# UNITED STATES PATENT AND TRADEMARK OFFICE

APPLICATION NO.	FILING DATE	FIRST NAMED INVENTOR	ATTORNEY DOCKET NO.	CONFIRMATION NO.
10/659,104	09/09/2003	Alan Qing Zhu	33380.007C	4331

# Office Action Summary

FIG. 4

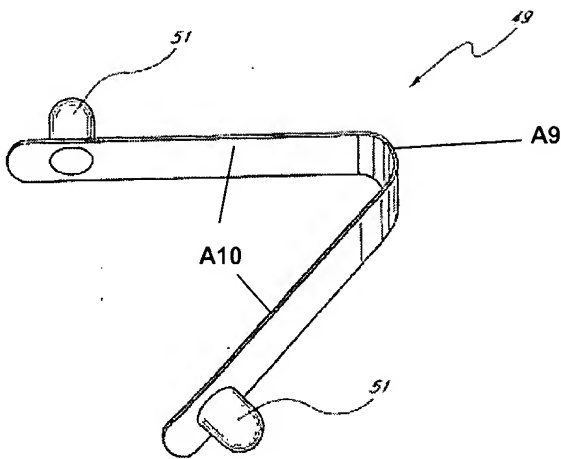
Regarding claim 1, Larsen discloses, in Figures 1E, 4 and 7, a modular picket fence comprising at least two spaced apart vertical posts (col. 6, lines 14-16), at least

two spaced apart horizontal tubular rails **24**, , spaced apart vertical tubular pickets **22**, and locking means **49** for locking the pickets **22** to the rails **24**. Each of the rails **24** has spaced apart apertures **46**. The apertures **46** on the rails **24** are aligned. The pickets **22** are secured in mutually parallel relationship to the rails **24**. Each of the pickets **22** has two opposite end portions **26** respectively inserted into the apertures **46**. Each of the end portions **26** has at least two oppositely disposed and aligned transverse apertures **33** (col. 7, lines 65-67).

The locking means **49** is for respectively locking each of the end portions **26** of each of the pickets **22** to the rails **24**. The locking means **49** comprises a one-piece generally U-shaped spring clip having a bent middle portion **A9** and two opposite end portions **A10** each having an outwardly protruding stopper **51**. Each stopper **51** has a right-angle side **A13**. The spring clip is inserted into each of the end portions **26** of the pickets **22** with each stopper **51** respectively protruding through the two transverse apertures **33** of the pickets **22**. Each of the end portions **26** of each of the pickets **22** is respectively inserted into one of the apertures **46** of the rails **24**. Each stopper **51** is respectively inserted in the end portions **26** of the pickets **22** respectively extending through the transverse apertures **33** of each of the end portions **26** of each of the pickets **22**, and also extending into and respectively engaging inside the rails **24** such that vertical movement of each of the pickets **22**, relative to the rails **24**, is prevented. However, Larsen fails to disclose attaching means for attaching the rails **24** to the posts and each stopper **51** having a ramp side.

Lucas teaches in Figure 3, each stopper 8 having a ramp side 11 for an automatic action of the stoppers in passing a rim of an opening (page 2, lines 54-59). Therefore, as taught by Lucas, it would have been obvious to one of ordinary skill in the art at the time the invention was made to include a ramp side on each stopper **51** to automate an action of each stopper **51** in passing a rim of the apertures **46**.
